SHAO SHORT PLAT

COVER SHEET AND PROJECT OVERVIEW

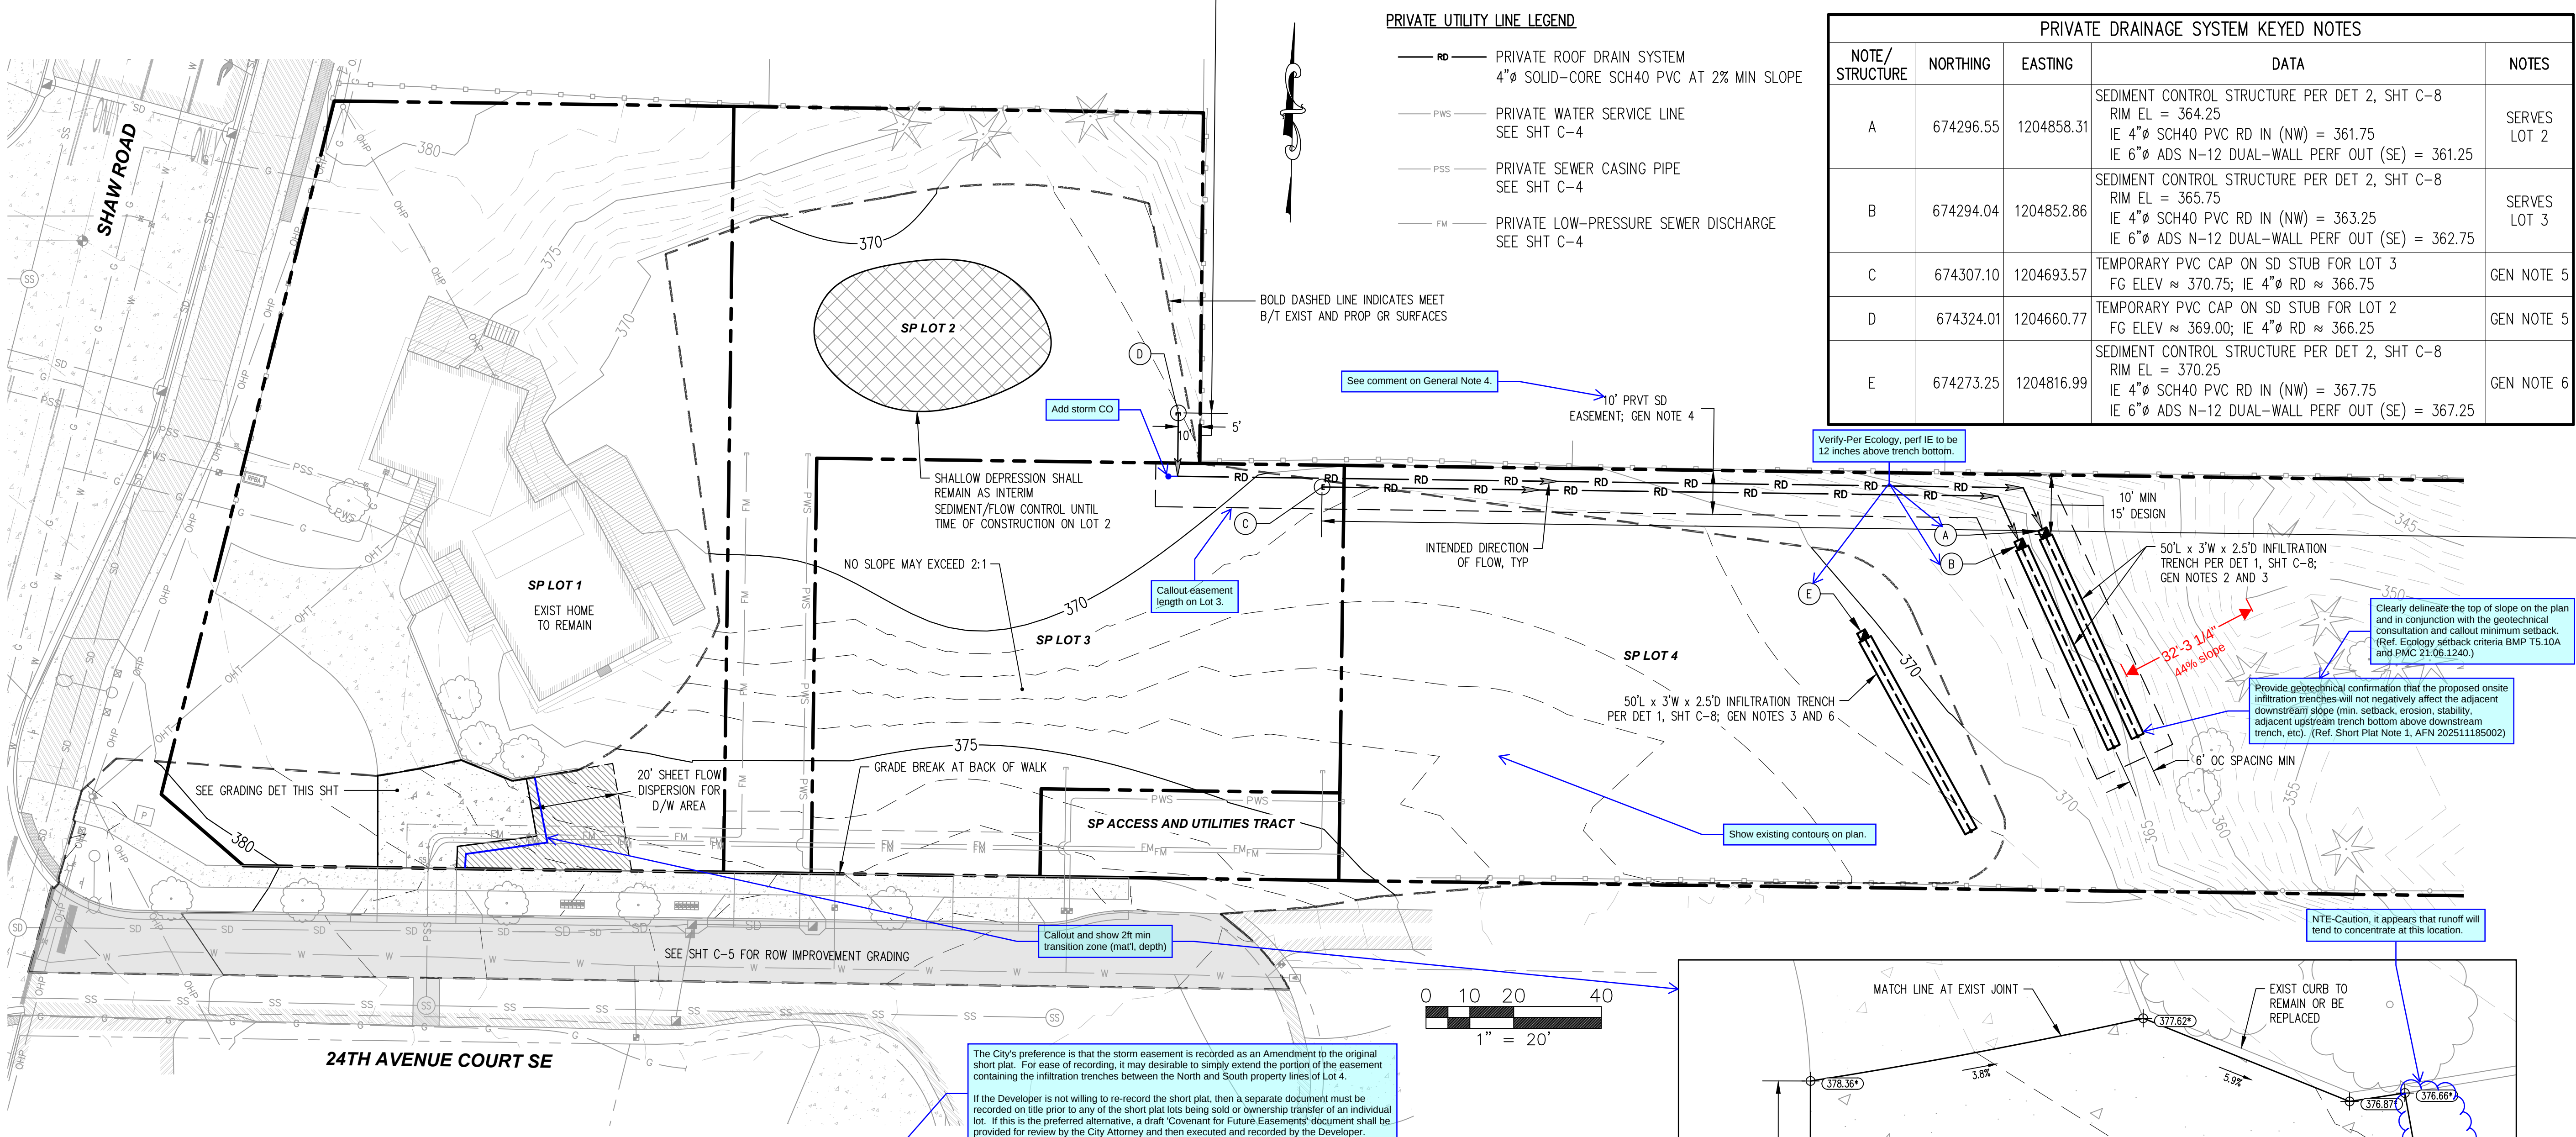
Add site specific Construction Sequence per CS 501.6

UTILITY CONNECTION PLAN

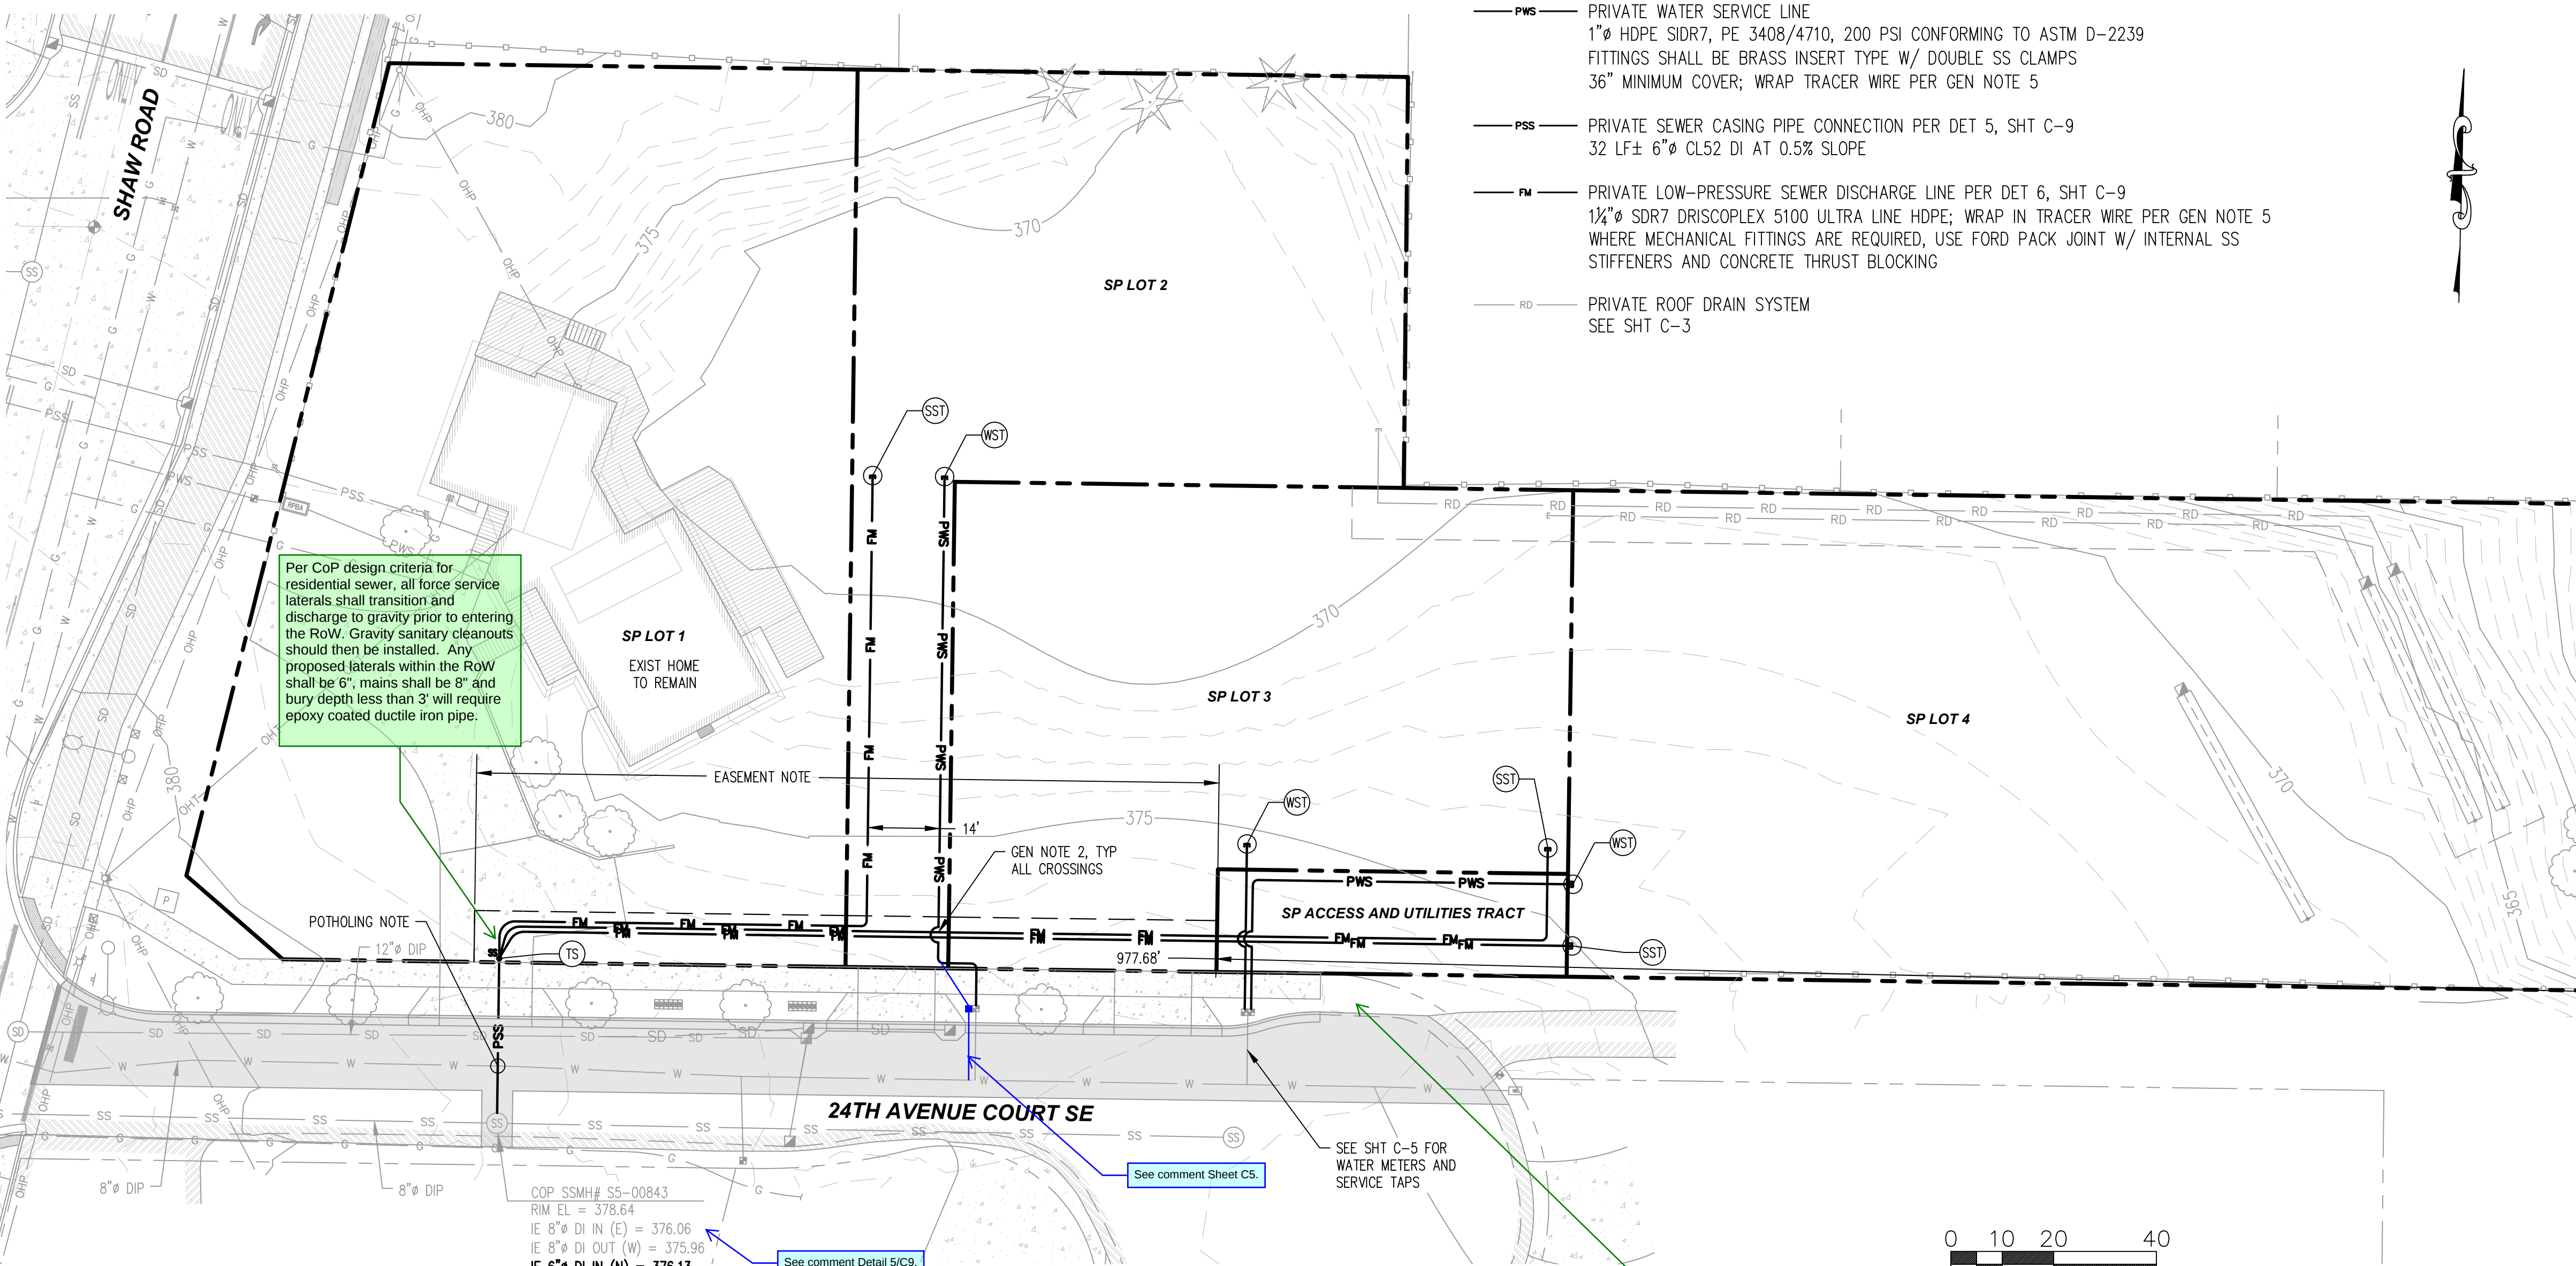
The approved short plat, AFN 202511185002, specifically indicates a "sewer" easement. If the existing easement is desired to be a "utility" easement, then short plat should be amended and re-recorded.

24TH AVENUE COURT
SOUTHEAST IMPROVEMENTS

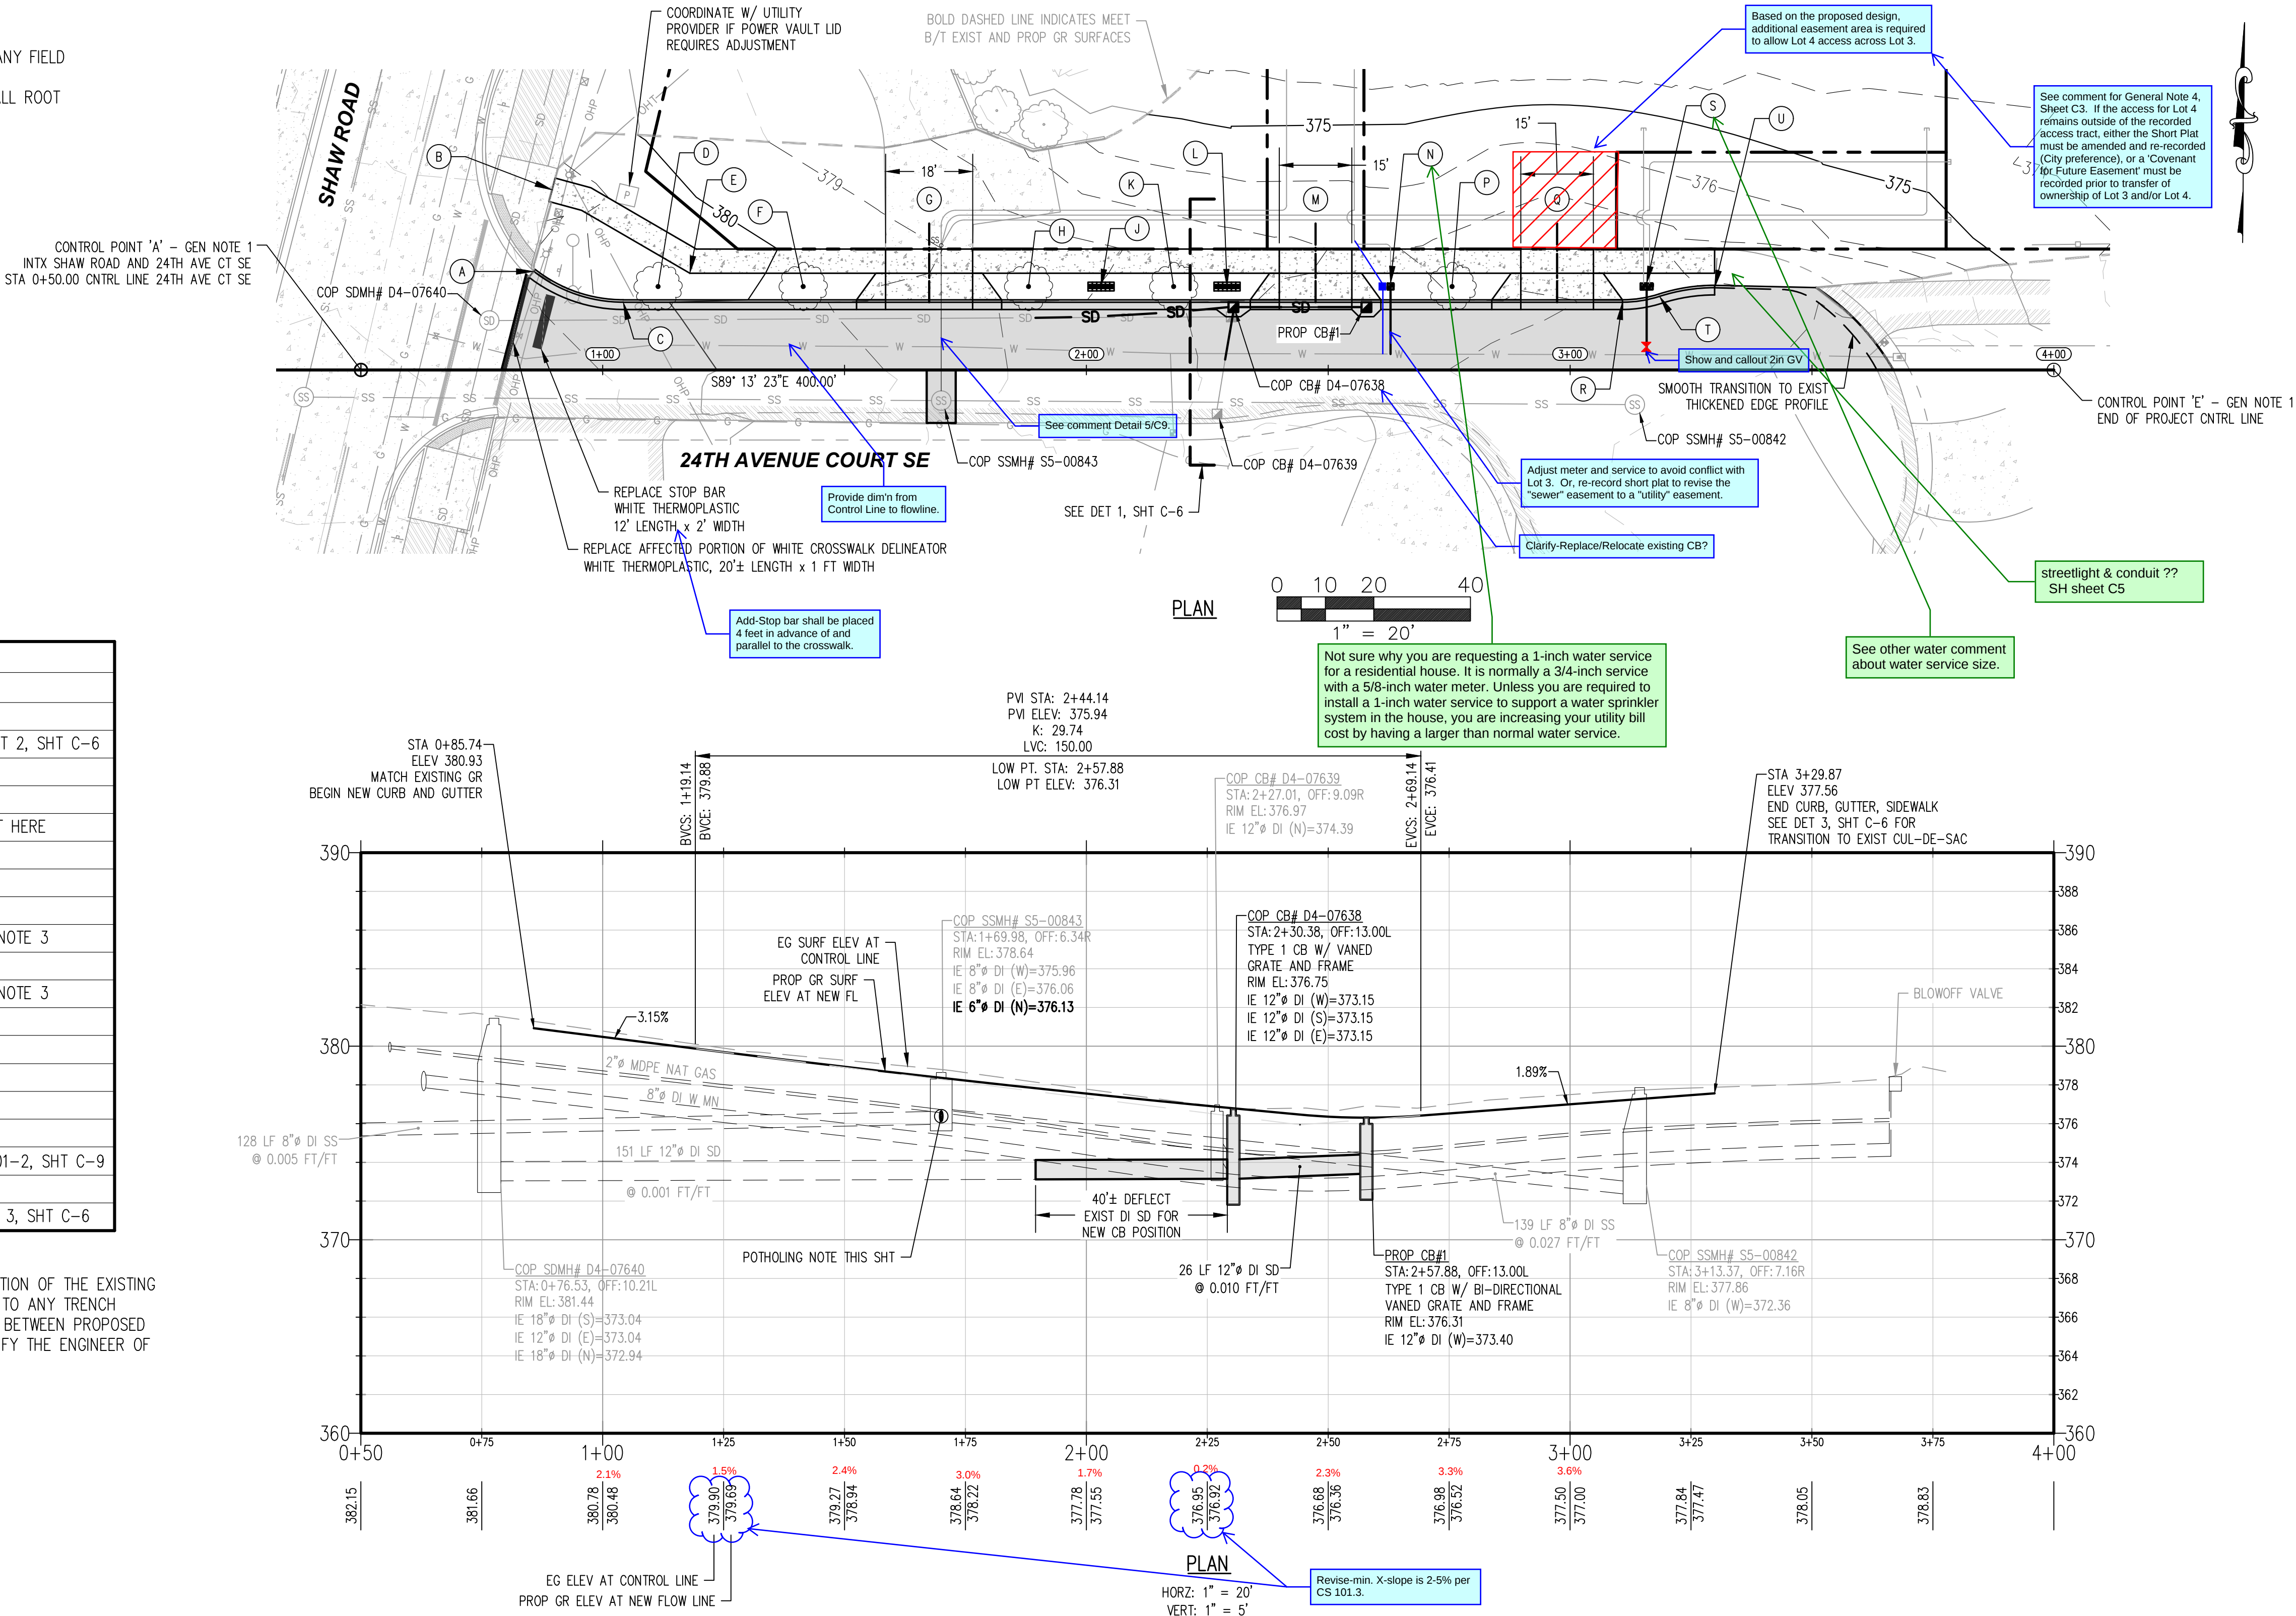
Streetlight per section 102.12 ? spare conduit for installation? SH sheet C4

6 PRIVATE DISCHARGE LINE
SCALE: NTS

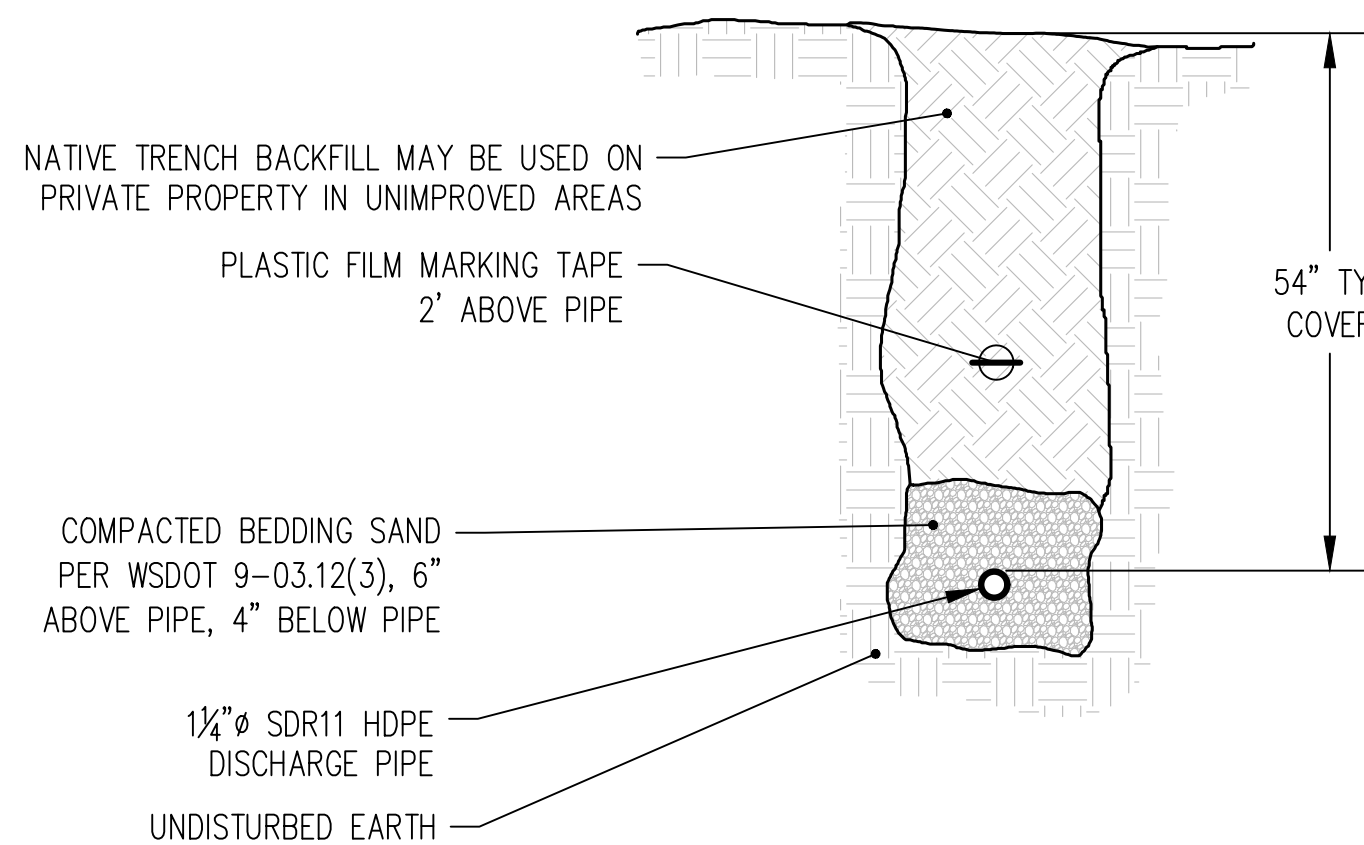
At the point of connection to the gravity side sewer, provide pipe restraint to prevent individual FM being pulled out of the side sewer due to hydraulic pressure and surging
